Federal Motor Vehicle Safety Standards; Ejection Mitigation; Final Rule

[Docket No. NHTSA–2013–0097]

ACTION: Final rule; response to petitions for reconsideration.

Figure 1 – Effect of a Grab Handle on the Target Locations of a 1st Row Window

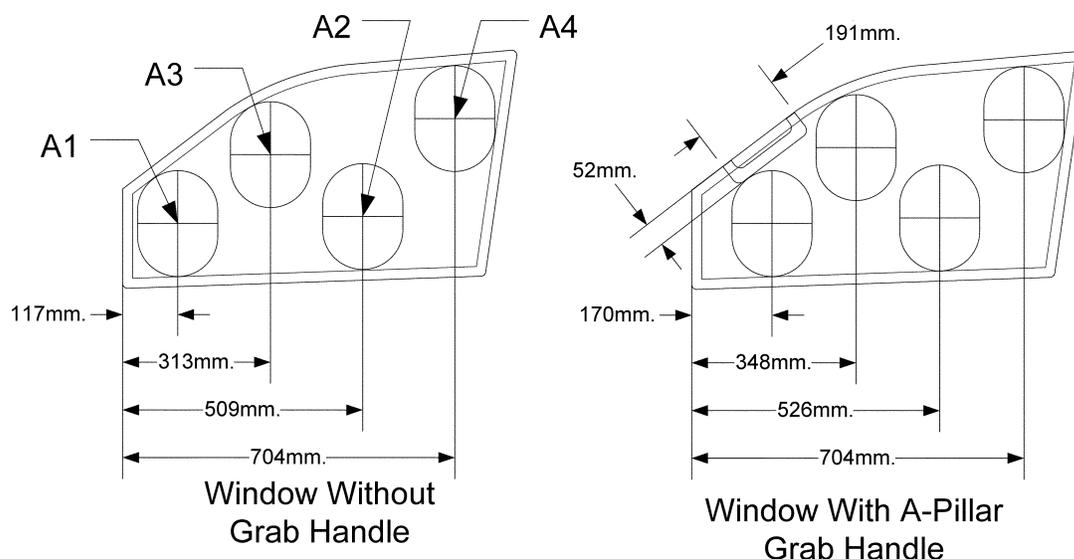
In its petition for reconsideration, the Alliance disagrees with the agency's decision in S6.3 to remove or adjust grab handles. The petitioner states that grab handles located inboard of the air bag deployment path are commonly attached through the headliner or A-pillar garnish trim to the vehicle structure. The petitioner states:

designed and there could be unintended interactions with the testing device.” The Alliance also states that, for handles located outboard of the air bag deployment path, the grab handles may also function as a reaction surface for curtain air bags. “If the handles were to be removed, the deployment characteristics and reaction surface of the airbag [sic] would be changed from the design intent. In addition, the surface of the pillar would be changed, which could lead to exposed mounting brackets and rough surfaces that can lead to tearing of the airbag [sic] and/or a change of the deployment characteristics.”

Moreover, we are concerned that the requested amendment would create a means to manipulate the test requirements, to enable designers to move the impactor away from weak points in the ejection mitigation countermeasure in a false way. Figure 1, below, depicts two renditions of a 1st row daylight opening. The illustration on the left shows the opening without a grab handle; the other shows a grab handle attached to the A-pillar. For convenience, we used an approximation of the target outline, rather than the exact cubic equation prescribed in the final rule. The target outline height and width are dimensionally correct relative to each other.

Similarly, Targets A3 and A4 have an average displacement of 132 mm and 15 mm, respectively. Moving target A3 towards the A4 target (by 35 mm, in our example) would likely reduce the displacement of the impactor at the A3 location. Finally, the original A2 target is moved rearwards toward the B-pillar (by 17 mm, in our example). Decreasing the proximity to the B-pillar may add support to the curtain, which will tend to reduce the impactor displacement.

real world. For grab handles, we have determined there is reason to remove the component (and the other items listed in S6.3) due to potential interference with the impactor. However, we concur that the grab handle should be removed with minimal disturbance to the trim.

Figure 2 – Graphic provided by ASC, showing a daylight opening with no top right-hand corner

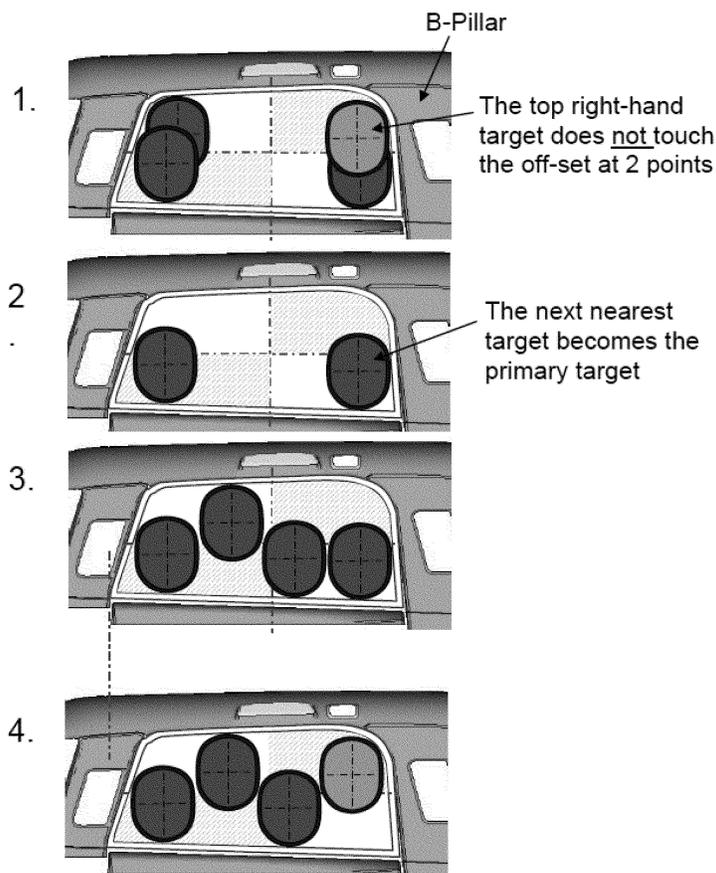
ASC asks for clarification of the targeting procedure for a window opening with a large radius, regarding the forward-upper quadrant of the daylight opening. It asks how NHTSA will position a target at the “corner” location(s) for this area of the window (top image (labeled “1”) in Figure 2, below.). ASC states that if the procedure is followed as written, the target would only contact the daylight opening offset-line at one point and, therefore, this quadrant would not contain a target. ASC states that S5.2.3.3 then specifies that the forward lower target would become the new primary target (image labeled “2” in Figure 2). ASC states that continuing with the specified test procedure, the selected targets would be as illustrated in the image labeled “3” in Figure 2. ASC believes that NHTSA intended the targets to appear as shown in the image labeled “4” rather than image 3 and asks for clarification of the procedure to achieve the target layout shown in image 4.

ASC is correct that the procedure of S5.2.3 results in the layout shown in image 3 in Figure 2. However, it was not our intent that the test procedure must specify placement of a target in the forward-upper quadrant of the window opening no matter the shape of the daylight opening. We believe that the absence of a corner in the forward-upper quadrant is not typical, so the final placement of the targets in the example shown is also not typical. NHTSA has not encountered a situation like this in any vehicle we tested.

Figure 3 (Figure “5a” in regulatory text)

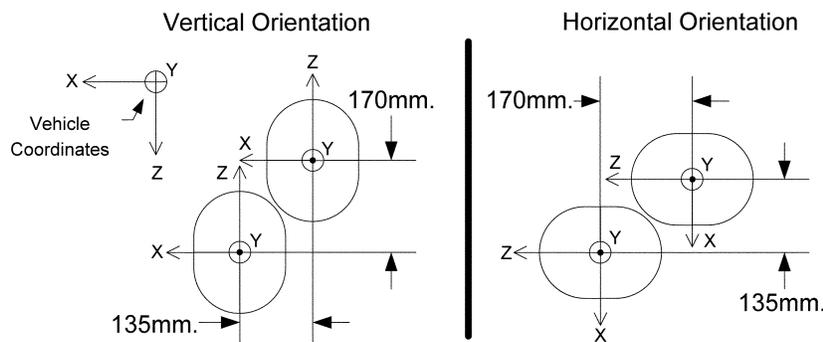
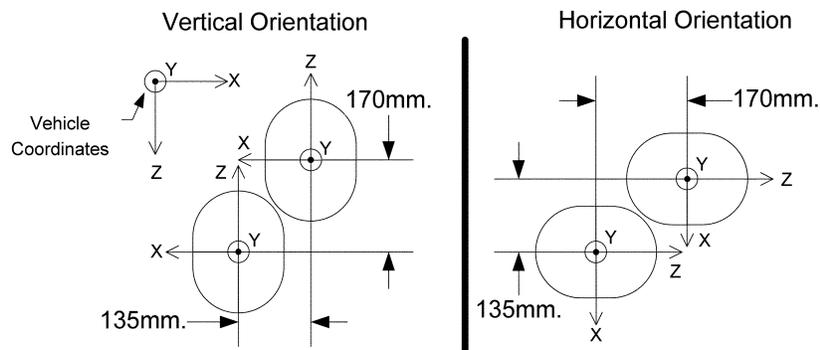
The Alliance believes that the reference coordinate axes used throughout the regulation, and particularly in S5.2, need illustrations and/or figures to better define the vehicle, headform and target axes, especially with rotation of the headform. TRW and ASC ask for clarification of S5.2.5.1.1 as to the specified distances between the target's local z-axis and x-axis, i.e., whether the distances remain constant irrespective of target orientation. Both the Alliance and ASC provide figures to illustrate their understanding of S5.2.5.1.1 and S5.2.5.2 and ask if their understanding is correct. They suggest that figures be added to the regulatory text to help clarify the relationship between vehicle and target axes when assessing possible target elimination.

We are granting this request. The figures submitted by the Alliance, TRW and ASC correctly interpret the regulatory text in S5.2.5.1.1. We agree that adding figures to the regulatory text would be helpful. We are adding the figures below to the regulatory text as new Figures 5a and 5b. Figure 3 below (new Figure 5a in the regulatory text) shows the vehicle and target coordinate systems from the perspective of a viewer facing the left side of the vehicle exterior. The minimum distance of 170 mm and 135 mm between the x and z axes, respectively, are also shown. The left side of the figure shows these minimum distances for vertically-oriented targets and the right side of the figure shows these for horizontally-oriented targets. Additionally, the right side of the figure provides the orientation of the z axis of the target specified in S5.2.5.2.

Figure 4 below (new Figure 5b in the regulatory text) shows the vehicle and target coordinate systems from the perspective of a viewer facing the right side of the vehicle exterior.

A reference to these new figures will be made in S5.2.5.1.1 and S5.2.5.2. Also, a typographical error is corrected in S5.2.5.1.1. The Alliance has noted that in the fourth sentence of S5.2.5.1.1, “y axis” is incorrectly referenced. The correct reference is “x axis.”

Figure 6 – Maximum overlap of targets under various scenarios

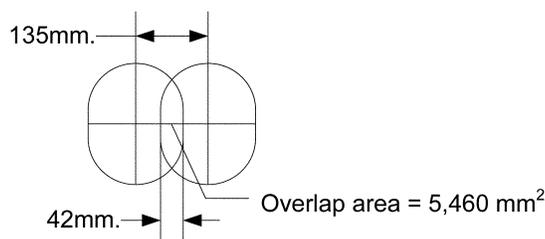
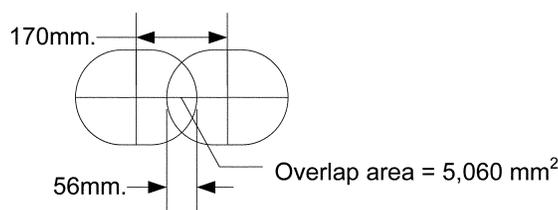
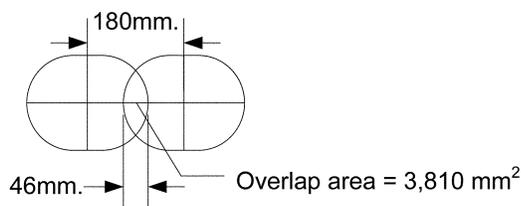
Example 3 is the situation for which ASC suggests the agency should make some form of accommodation to reduce the potential overlap. However, we see that, when compared to Examples 1 and 2, Example 3 has a smaller area of overlap than Examples 1 or 2 and less linear overlap than Example 2. The maximum potential overlap under S5.2.5.1.2 for horizontal targets is, in fact, less than the maximum potential target overlap for other target configurations. All-in-all, we do not believe that these targeting scenarios allow for excessive overlap. The targeting procedures ensure that the ejection mitigation countermeasure is evaluated throughout coverage of the daylight opening. Accordingly, because we do not believe the overlap allowed for horizontal targets by S5.2.5.1.2 is excessive, we see no reason to limit it further.

We decline to increase the 360 mm distance for horizontally-oriented targets.³² There is a potential for three horizontal targets to represent the final target locations under provisions of S5.2.5.2. The question presented is whether the overlap of the horizontal targets is excessive compared to the overlap “permitted” by the standard for vertical targeting configurations. To help in this assessment we have constructed Figure 6, below. This figure shows the maximum allowable overlap of targets under three different scenarios.

Figure 7
(Showing Figure 16 in NPRM)

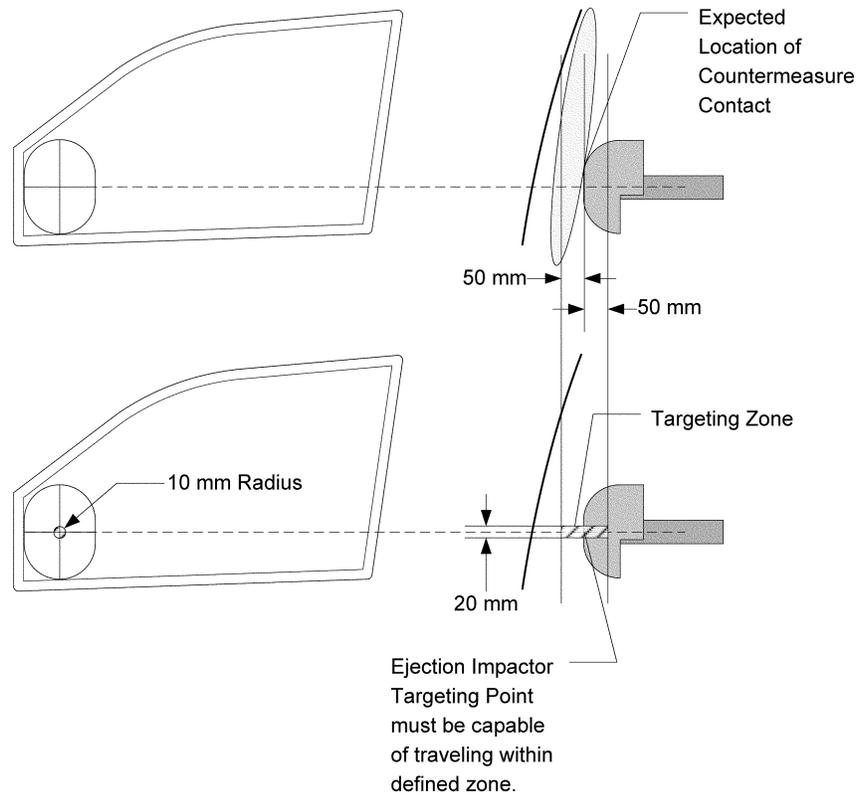
As shown in Figure 16, a zone could be established by first determining the “ejection impactor targeting point,” the intersection of the x- and y-axes on the outer surface of the headform. Next, the location of first contact between the impactor and the ejection mitigation countermeasure (e.g., ejection mitigation air bag curtain) would be determined, based on the location of the target outlines using the methodology in the compliance test specified for identifying the target outlines. A 100 mm wide zone would be determined by defining two vertical longitudinal planes that are 50 mm on either side of the expected location of contact by the impactor with the countermeasure. These longitudinal planes define a portion of the strike zone. The other portion of the zone would be defined by locating the axis normal to and passing through the target outline center. As the impactor targeting point passes at test speed through the 100 mm wide zone (as it passes “over the plate,” using the baseball analogy), it must stay within ± 10 mm of the axis passing through the center of the target outline center (continuing the analogy, it must stay within the vertical zone bounded by the batter’s knees and chest). This assessment would not be conducted with an ejection mitigation air bag curtain

We are granting the request to revise S7.4. The Alliance is correct that the zone specified in S7.4 is a cylinder with a 10 mm radius. However, “D” does not represent the line segment that the cylinder is centered around. Rather, “D” was intended to be a point of reference for the theoretical point of contact with the countermeasure. In response to the Alliance’s comment that vertical and longitudinal planes cannot be defined in vehicle coordinates as forward and rearward of a lateral segment, the terms

After reading the Alliance’s petition, we have revised S7.4 solely for purposes of clarifying it. No substantive change is intended. Among other things, we have rewritten S7.4 to indicate the cylindrical nature of the zone of interest and to eliminate the reference to distance “D,” since the reference to D was confusing to the petitioner.
